STAFF REPORT AND RECOMMENDATION TO THE DESIGN COMMISSION

CASE FILE: LU 16-214234 DZM – Modera Glisan
[505 NW 14TH AVENUE]; PC # 16-175807
REVIEW BY: Design Commission
WHEN: December 15, 2016 at 1:30 PM
WHERE: 1900 SW Fourth Ave., Suite 2500A
Portland, OR 97201

Exhibit C.06

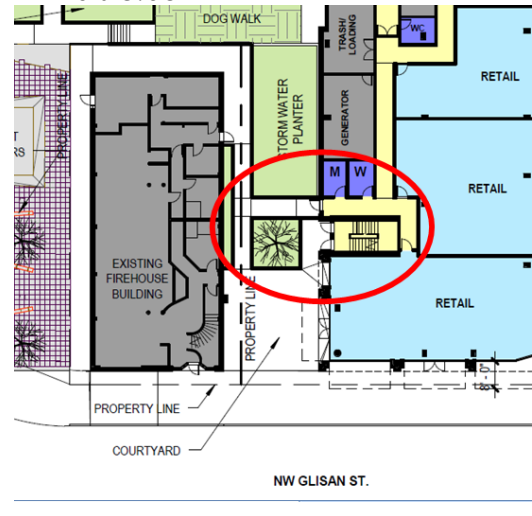
a) West-facing stair tower expression.

Regarding the west-facing façade of the 10-story building mass, the tall solid metal panel expression of the stair tower appears to distract from the otherwise regular heavy masonry structural expression of the building's composition.

Additionally, by emphasizing the strong vertical expression of the tower, the element itself becomes a significant feature of the overall building design, and while true to the function within, calls attention to otherwise 'back-of-house' functionality at the ground floor and rooftop. The stair tower provides access and egress to the rooftop pool level, and mandatory egress at a screened corner of the otherwise prominent public plaza between Modera Glisan and the Portland Firehouse #3.

b) SE corner rooftop condition.

With regard to the SE corner parapet design, the erosion of the upper corner and addition of a projecting canopy appears out of character with the strong masonry expression of the River District context and immediately adjacent buildings. As with the suggestion that the stair tower massing be incorporated within the otherwise strong masonry façade, this corner condition should also continue the masonry façade and pattern completely to the cornice, and the canopy projection eliminated, to provide a stronger relationship to the adjacent context. With additional design refinement, these guidelines could be met.

Were the stair tower frontage to mimic the strong masonry expression of the building design by internalizing the vertical stair circulation and reconfiguring the floor layouts to provide additional floor area and/or an additional vertical bay of projecting balconies that are already present within the building composition, these guidelines could be met.

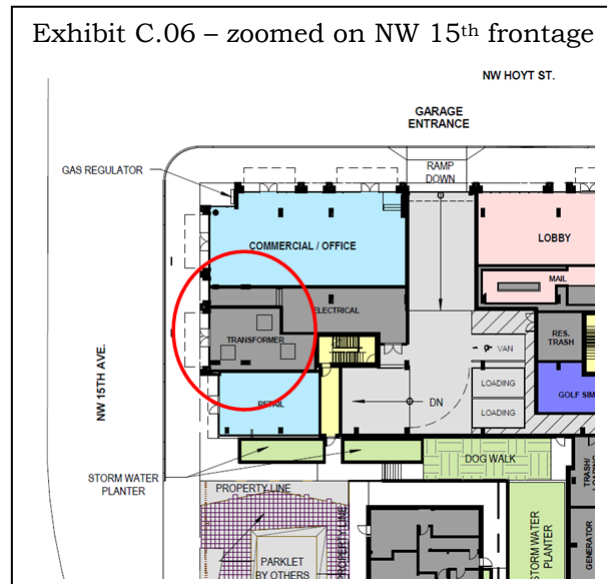
a) NW 15th Avenue storefront electrical transformer frontage.

Regarding the NW 15th Avenue frontage, a missed retail or office opportunity exists by the location of at grade electrical transformers within the storefront frontage. As the adjacent NW 15th Avenue ROW is available for underground transformers, the applicant should continue their coordination with the utility provider and PBOT to redesign the proposal. It should be noted that an underground location in the public plaza area adjacent to the 10-story tower would also not be appropriate due to the impact of vault lids within the pedestrian plaza. Please note that a Design Exception will be required by PBOT before approval in the NW 15th Avenue ROW can be issued. Until a revised proposal is submitted and approved for the electrical transformers to be located outside of the building's ground floor storefront area, these guidelines are not met.

b) Plaza frontages at southern and western building ground floor that surround the Historic Firehouse #3.

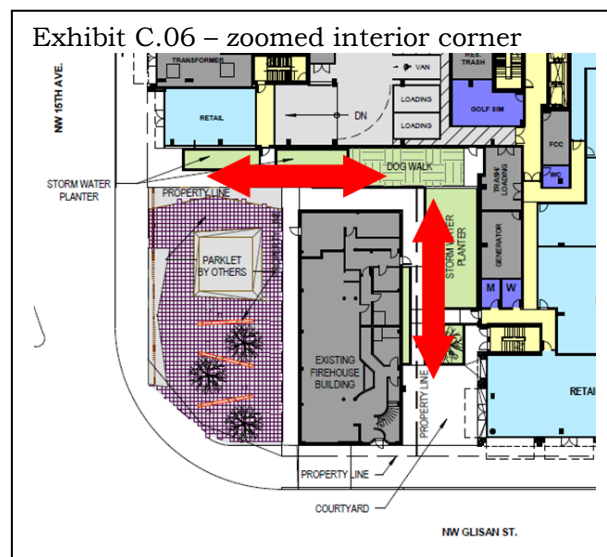
In regards to the plaza frontages, a similar missed opportunity exists along the interior ground floor frontages of the west and south elevations of the proposal facing the parklet [by others] and the Portland Firehouse #3. The proposal is for largely inactive uses such as large scale stormwater planters, dog walk area, trash and generator frontages. Were the adjacent ground level further activated by additional retail and/or office uses with entrances at the ground level – including potential ground level improvements to the Portland Firehouse #3, both of these two public spaces would be enhanced, and a unique and vibrant mid-block connection between them created. Without additional design development and ground floor activation of these spaces, these guidelines are not met.
